Service Bulletin

No. : MZ09-136

Model: SR6004, SR5004

Subject: The unit might be turning on the "protection-mode (Standby LED is flashing at high speed)".

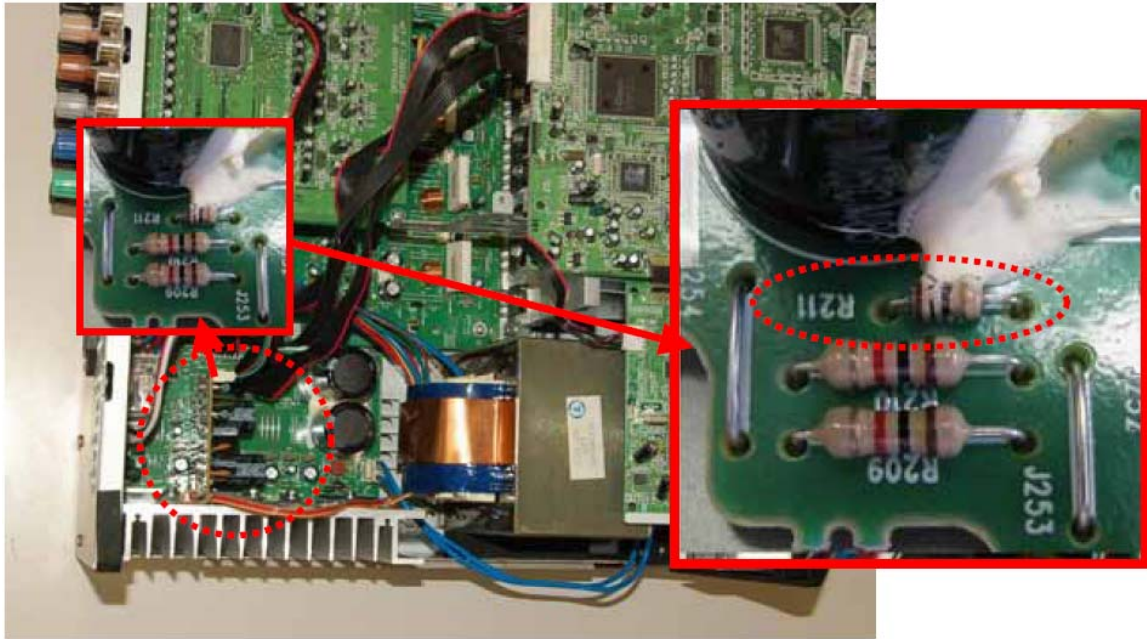
Symptom: Standby LED flashes at high speed.

Cause: If customer connects the specific HDMI cable or extra HDMI repeater to the unit, current of grounding circuit will be increased, and the grounding level is not stable. Therefore balance of voltage of power supply (+/-12Volts) is not stable, and then the unit might be turning on the "protection-mode".

Solution: Please short the both end of R211 (10 ohms).

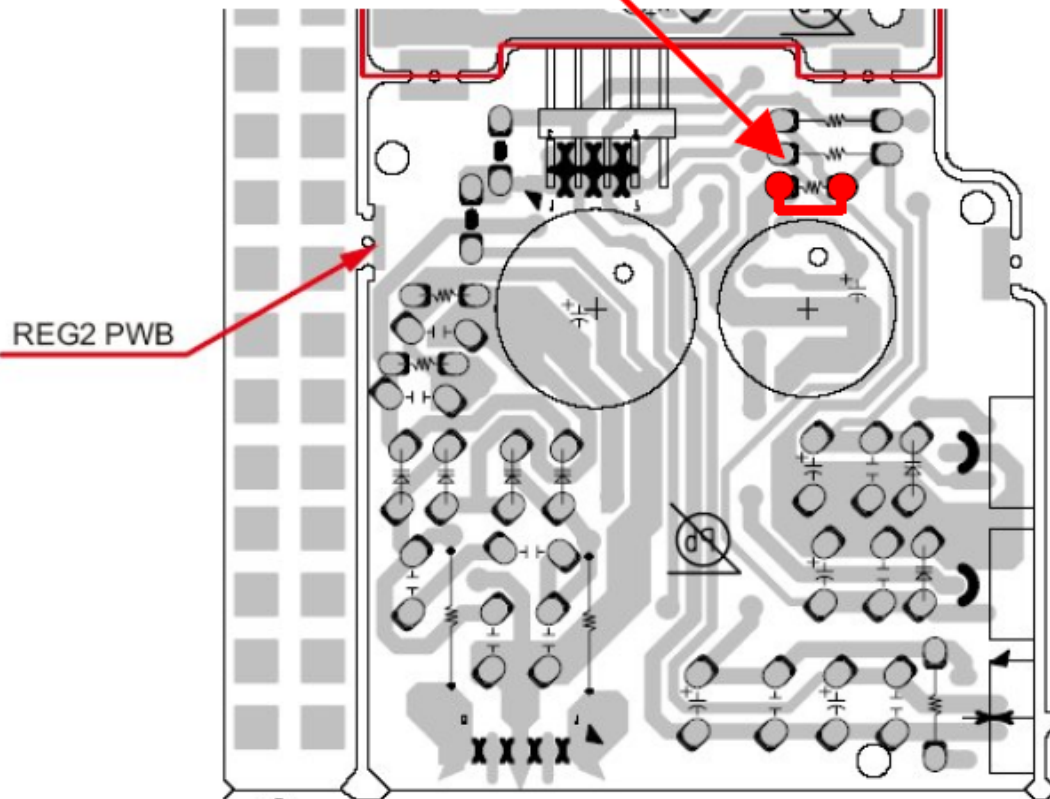
1) Remove the "REG PWB (REG2 PWB)" ASSY from the unit.

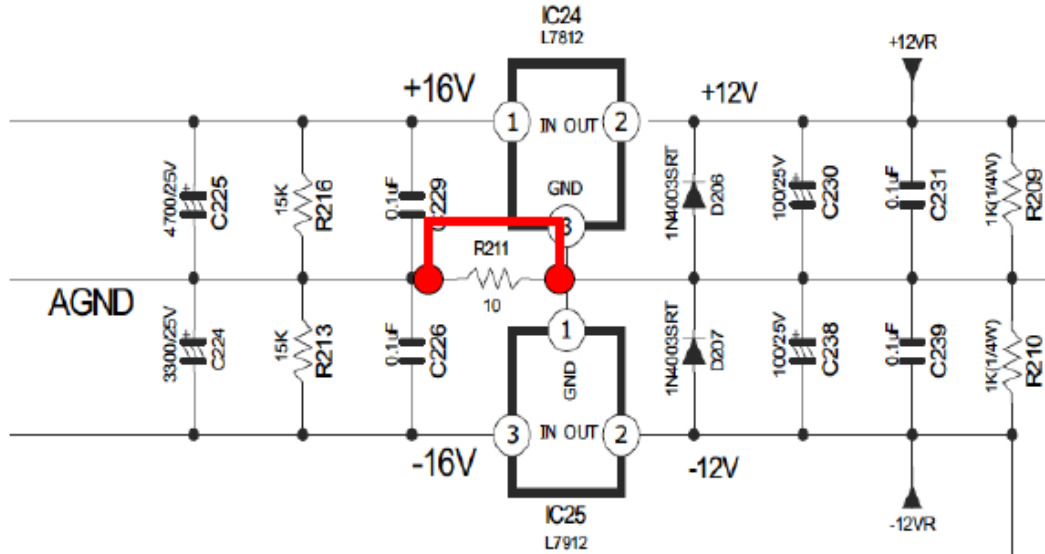
2) Short between both lands of pattern side of the R211 by thin copper wire.
(Please do not cut the R211 10 ohms.)
